National Transportation Safety Board

Date: March 17, 1998
In reply refer to: A-98-40

On June 17, 1997, just after takeoff from Las Vegas, Nevada, a Reno Air McDonnell Douglas MD-83 airplane, N875RA, operating as flight 516, experienced an uncontained failure of the No. 1 (left) engine, a Pratt & Whitney (P&W) JT8D-219, serial number (SN) 708177. The airplane returned to Las Vegas and landed without further incident. The airplane was operating on an instrument flight rules flight plan under the provisions of Title 14 Code of Federal Regulations Part 121 as a regularly scheduled passenger flight from Las Vegas to Colorado Springs, Colorado. The investigation of this incident is continuing; however, information gathered thus far raises safety concerns that the National Transportation Safety Board believes require Federal Aviation Administration (FAA) action.

Figure 1 Containment Shield Configuration

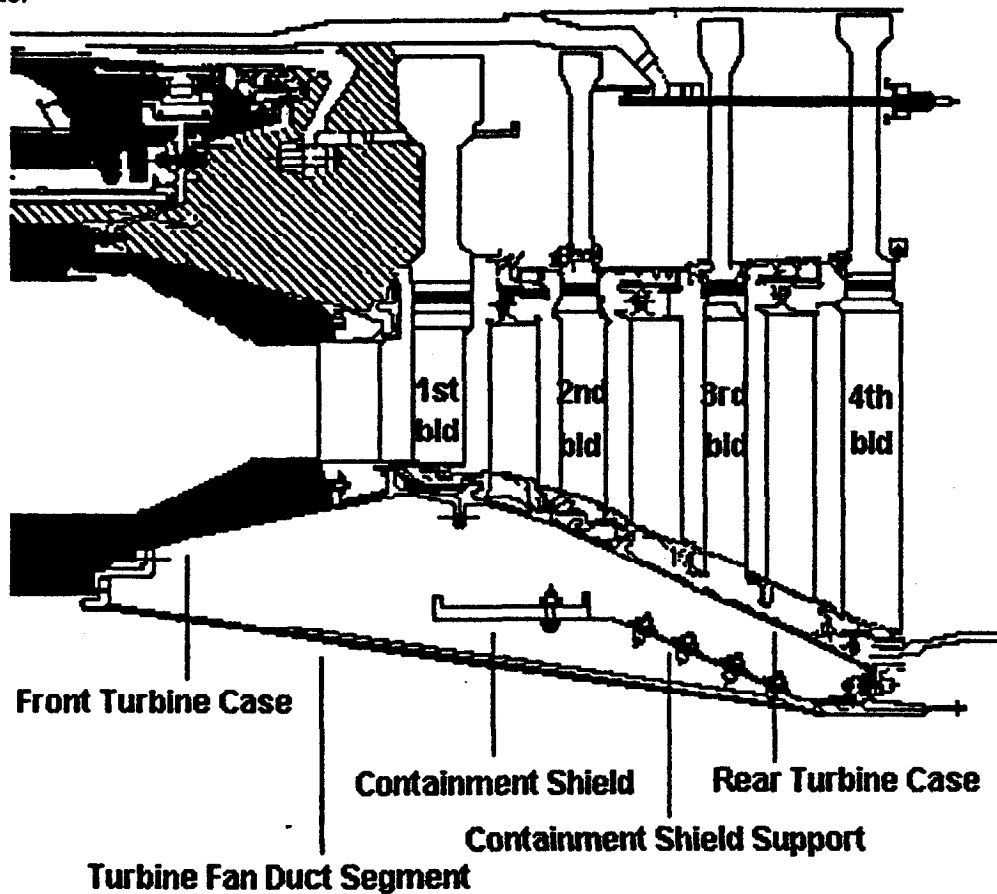
applicable to all JT8D-209, -217, -217A, -217C, and -219 turbofan engines. The containment shield is a clam shell design consisting of two half-shields joined by clevis plates and supported by a cantilevered shield support attached to the HPT rear flange. Considerable impact damage (engine debris) was observed on the inner diameter (ID) of the containment shield; however, the shield remained intact. The impact of turbine material on the lower shield shifted it outward and aft from its normal installed position, buckling its support. First-stage turbine blades and 2nd-stage turbine vanes had exited the engine through the openings between the HPT and LPT case flanges and deflected off the containment shield ID while exiting the engine and before striking the airframe.

The Reno Air and Centennial Airlines incidents have shown that the JT8D-200 series engine HPT containment shield design is inadequate to prevent all turbine parts from being liberated because the support is insufficient to sustain the shield in the proper location when impacted by some exiting turbine material. In addition, the incidents have shown that the containment shield is not wide enough nor the sidewalls deep enough to ensure that exiting material will be contained under a variety of exit paths. The Safety Board is concerned that the current containment shield cannot prevent HPT part liberation and therefore believes that the FAA should evaluate the current P&W JT8D-200 series engine HPT containment shield required by AD 93-23-10 and, if shown by evaluation, require that it be replaced with an HPT containment shield that would provide a larger coverage area and more impact resistance and durability.

Evaluate the current Pratt & Whitney JT8D-200 series engine high-pressure turbine (HPT) containment shield required by Airworthiness Directive 93-23-10 and, if shown by evaluation, require that it be replaced with an HPT containment shield that would provide a larger coverage area and more impact resistance and durability. (A-98-40)
